GULF STATES UTILITIES COMPANY

River Bend Station - Unit 1
Docket No. 50-458

Enclosed is Gulf States Utilities Company's (GSU) partial response to the Nuclear Regulatory Commission's (NRC) Safety Evaluation Report (SER) confirmatory item No. (3) identified in Section 2.5.5.2 regarding the factor of safety against failure for all slopes adjacent to the Unit 1 structures. During a telephone conference on June 15, 1984, further clarification was provided to GSU by the NRC's Structural and Geotechnical Engineering Branch (SGEB) reviewer, Mr. Banad Jagannath. The information requested is addressed herein. An additional response addressing the factor of safety against sliding for the service water tunnel (G) that leads to Unit 2 excavation area is scheduled for submittal the week of July 2, 1984.

FIGURE 2.5-72b

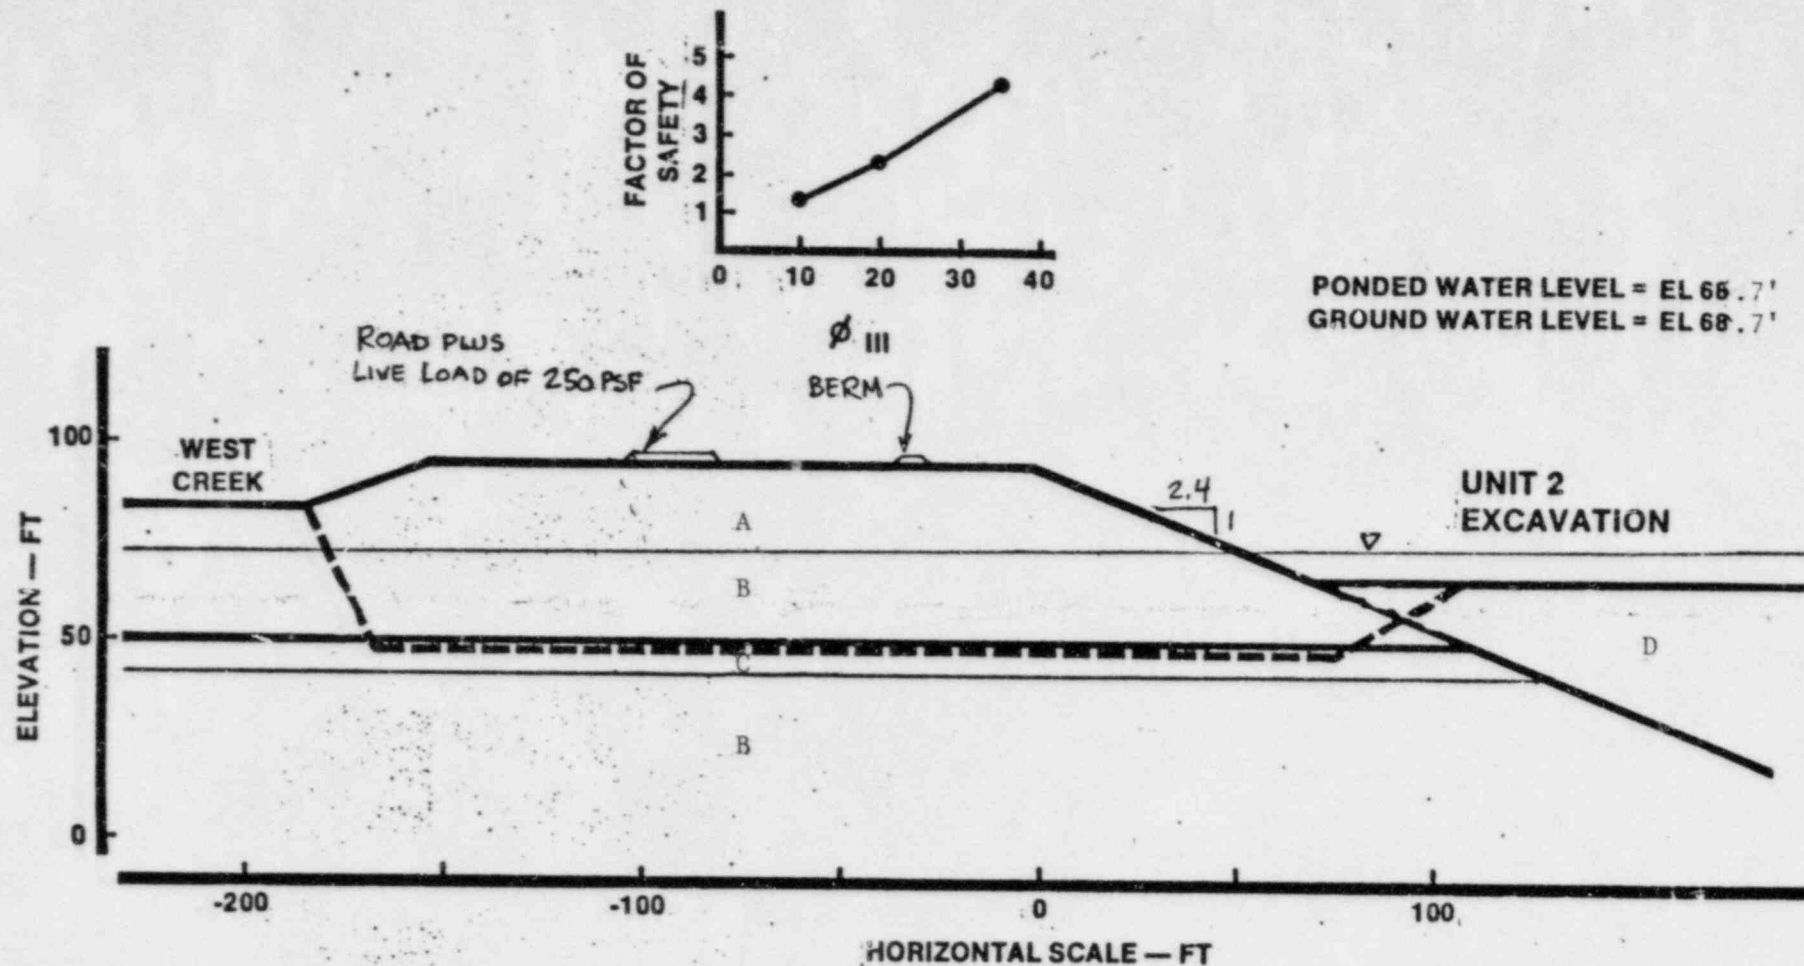
approximately 75 percent, 50 percent, and 0 percent liquefaction, respectively. Fig 2.5-72b shows the geometry that was used to model the west slope.

Given the adequate factors of safety for these two conditions, it is concluded that the safe operation of Unit 1 is not impacted by the slopes associated with the Unit 2 excavation. The results of the Morgenstern-Price analysis for SSE loading are summarized on Fig. 2.5-72b. The analysis shows that for the extremely unlikely event of liquefaction of 75 percent of the soils at elevation 50 ft msl (corresponding to $\phi_{III}=10$ deg) the factor of safety against sliding is approximately 1.3. Given the conservatism of the analysis that results in a factor of safety of 1.3, it is concluded that the cut slopes of the Unit 2 area are stable.

FIGURE 2.5-72C

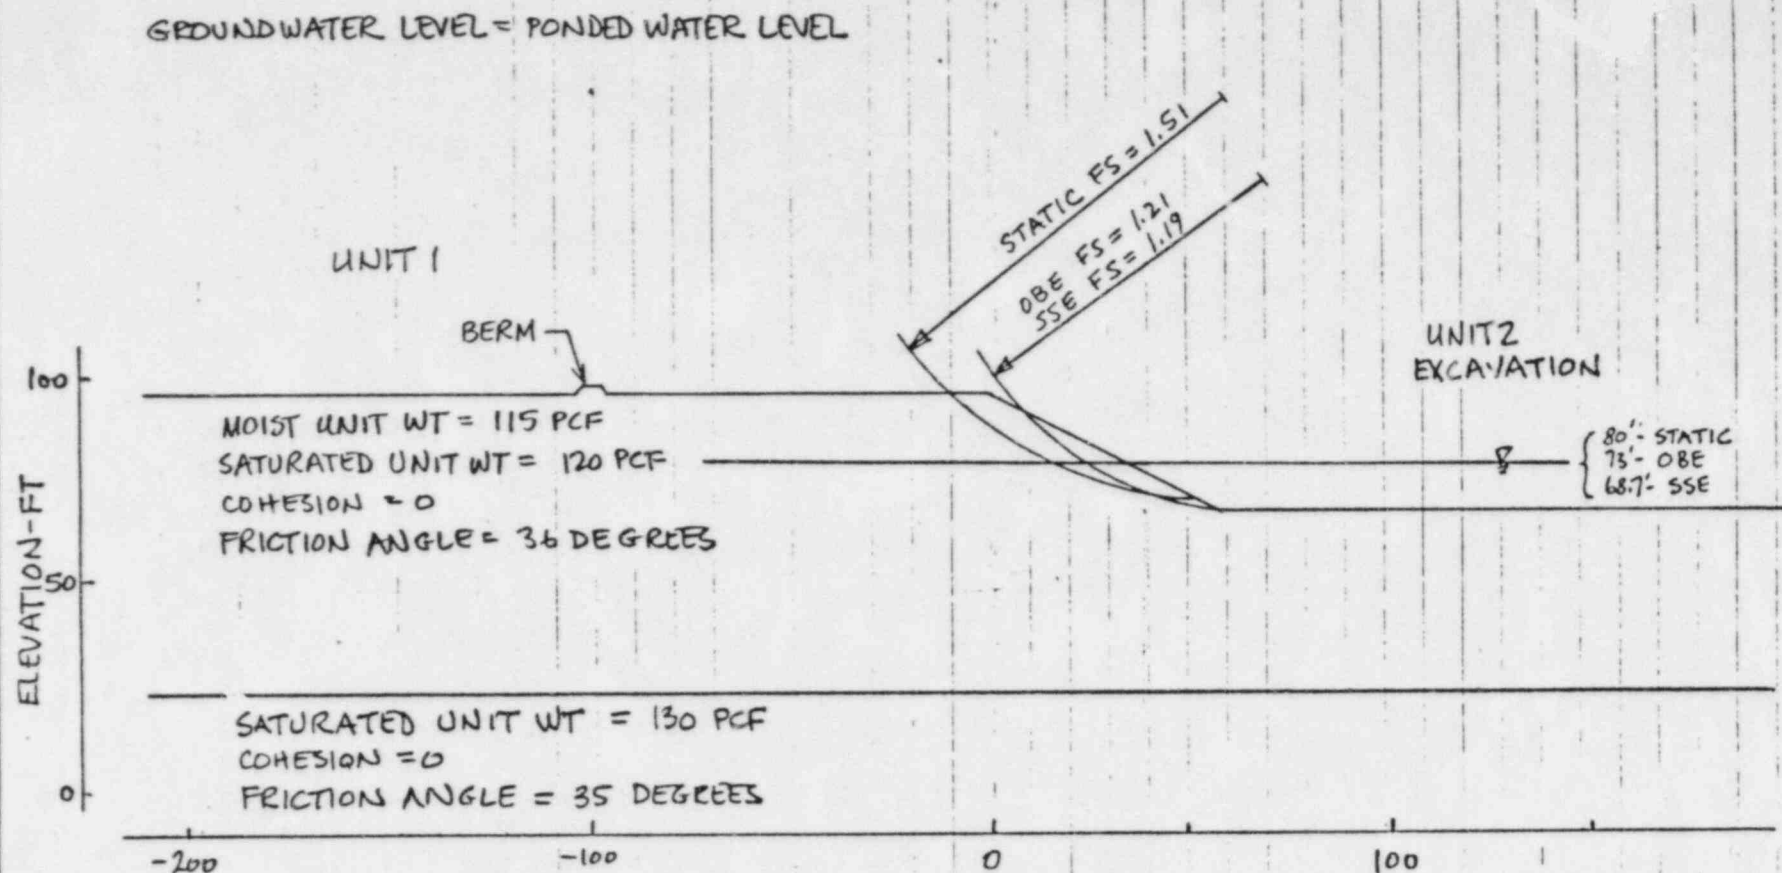
The slopes located east of Unit 2 were analyzed using the simplified Bishop Method. Since these slopes are constructed of engineered backfill as described in Section 2.5.4.5.3, no liquefaction was postulated. The geometry analyzed and typical results of the computerized calculation are shown on Fig. 2.5-72c. In general, for trial circles at the same center, the factor of safety decreases with decreasing radius, indicating that the critical factor of safety corresponds to an infinite slope type failure. Analysis of the infinite slope problem under SSE loading gives a factor of safety of 1.12 which corresponds to minor surficial sloughing at the face of the slope. This analysis is based on a friction angle of the backfill material equal to 36 deg. Laboratory testing of backfill samples (Appendix 2M - Triaxial S Tests) indicate that for backfill compacted to 89 percent relative density a friction angle of 42 deg can be justified. Using a friction angle of 42 deg in the infinite slope analysis results in a factor of safety of approximately 1.4. Failure surfaces large enough to breach the berm have factors of safety in excess of 3. It is concluded that the backfill slopes east of the Unit 2 excavation are stable.

FIGURE 2.5-72d

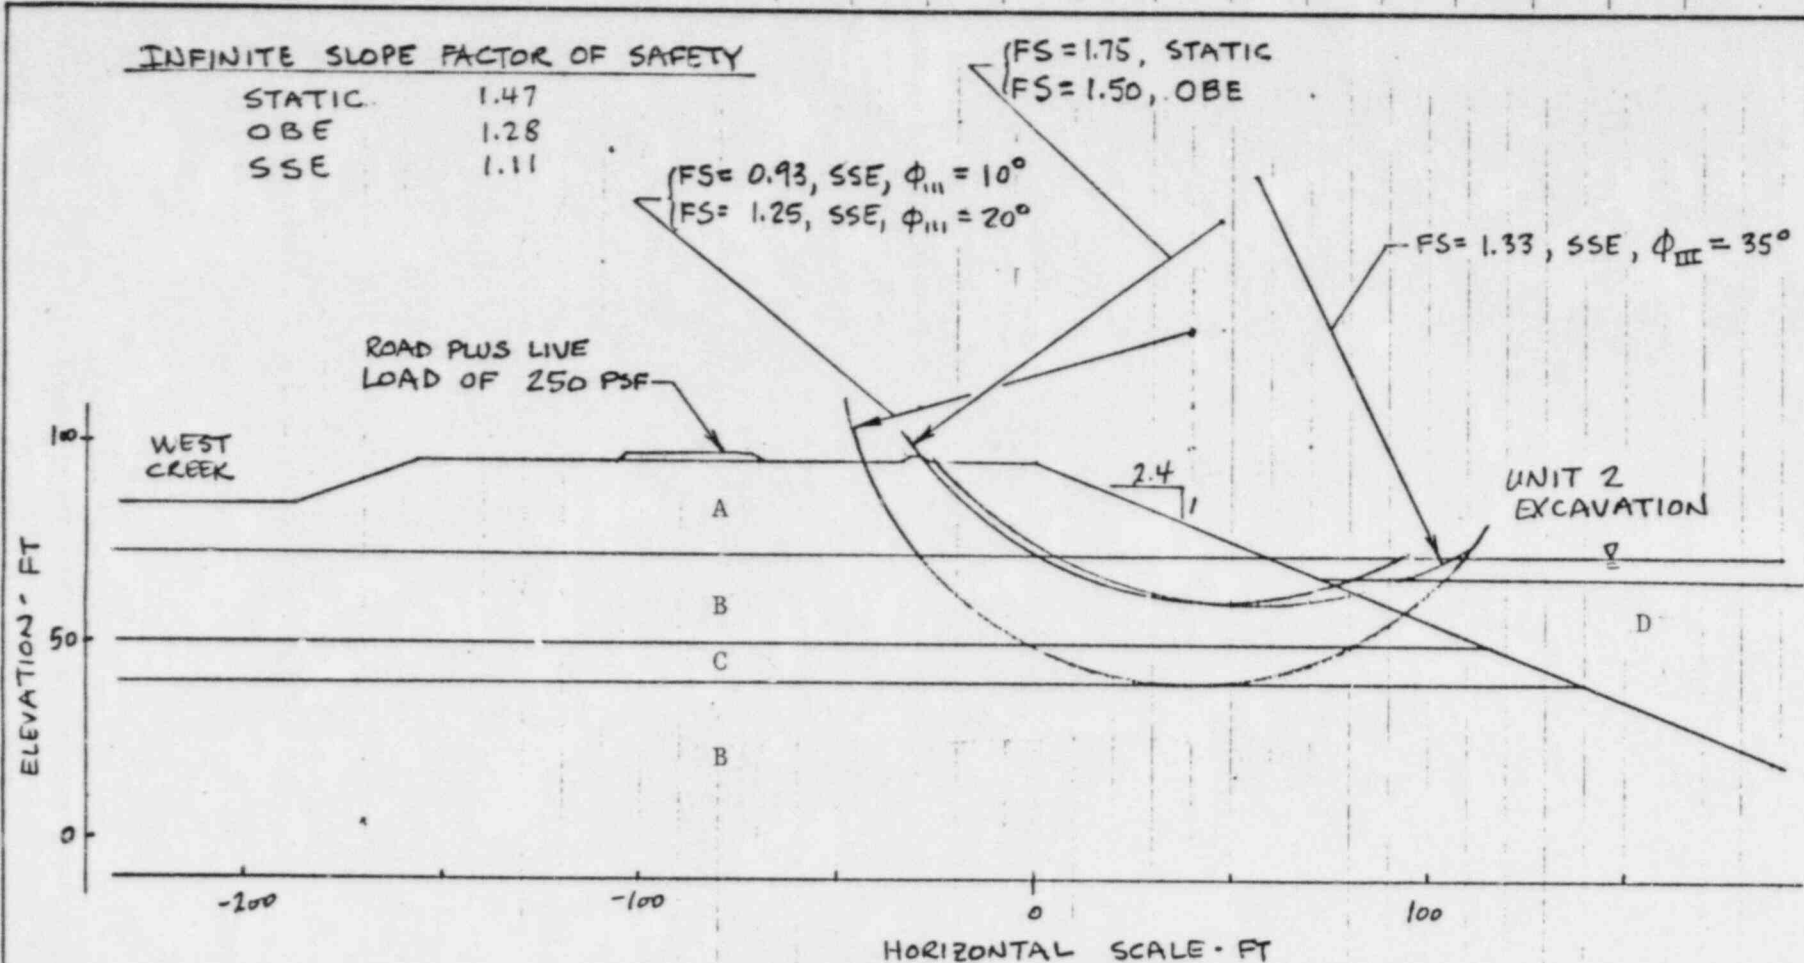
For analyses on cut slopes the effects of both the berm and live loads due to traffic on adjacent roadways are included. The geometry analyzed is shown on Figures 2.5-72b and 2.5-72d.

The local stability of the face of the cut slopes under the OBE loading was evaluated using the simplified Bishop Method. The geometry analysed and typical results of the computerized calculation are shown in Figure 2.5-72d. Also shown in that figure, is the factor of safety against an infinite slope failure under all loading conditions. It is concluded that the face of cut slopes is stable under the OBE and static conditions. Under SSE loading, analysis shows in stability at the face of the slope which may breach the berm. However, as stated in Section 2.5.5.2.1 safe operation of Unit 1 would not be affected.

FIGURE 2.5-72a

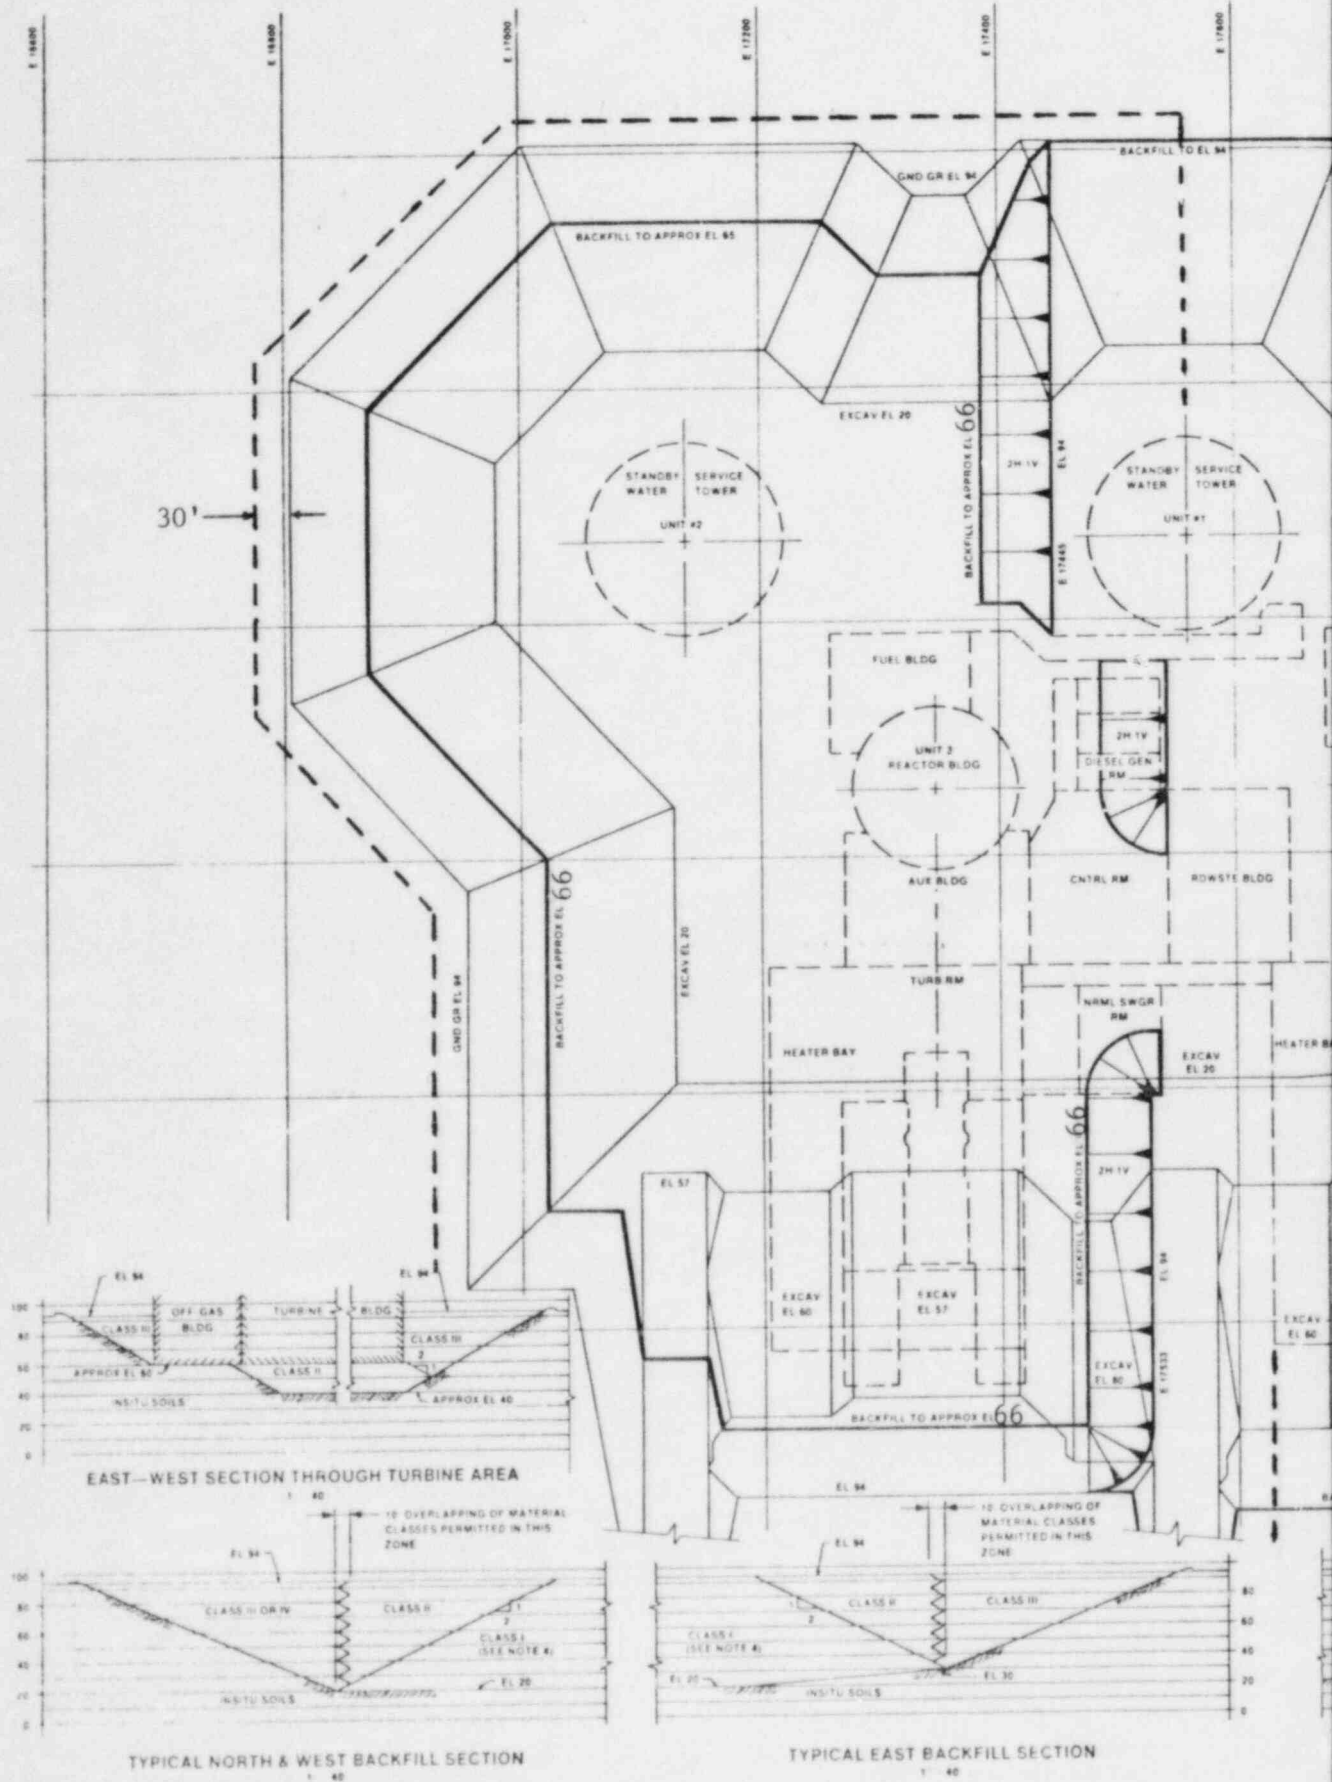
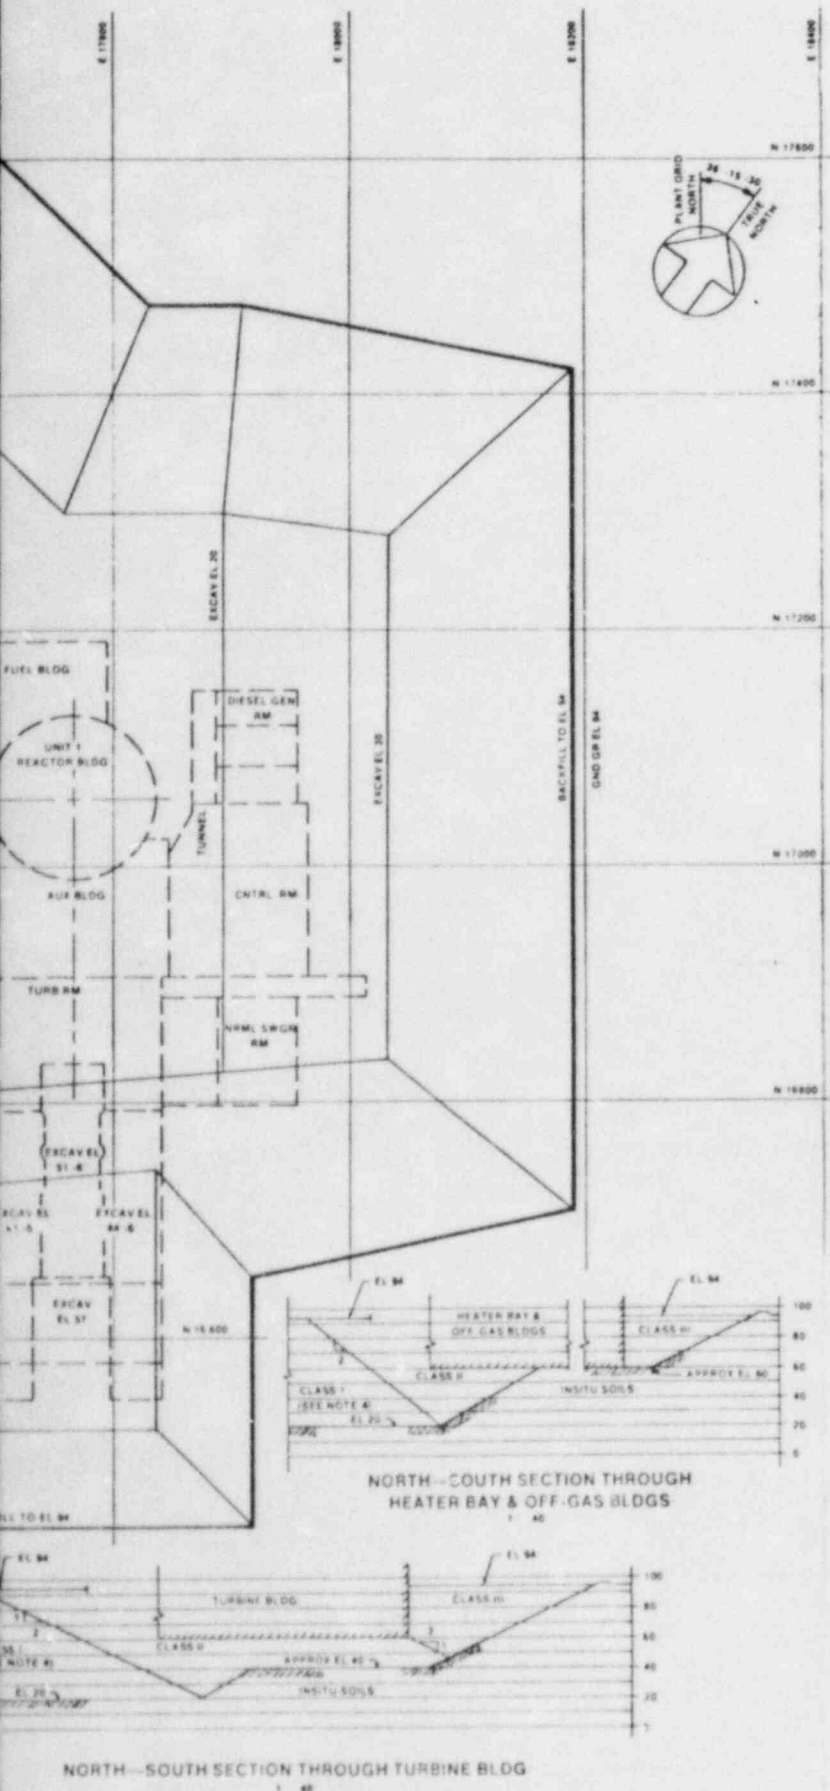
The slopes ^{and berm location} in the Unit 2 excavation are shown in plan on Fig. 2.5-72a. The slopes located to the north, west, and south of the Unit 2 area are cut slopes in natural soils. The slopes located east of the Unit 2 area are constructed of backfill.
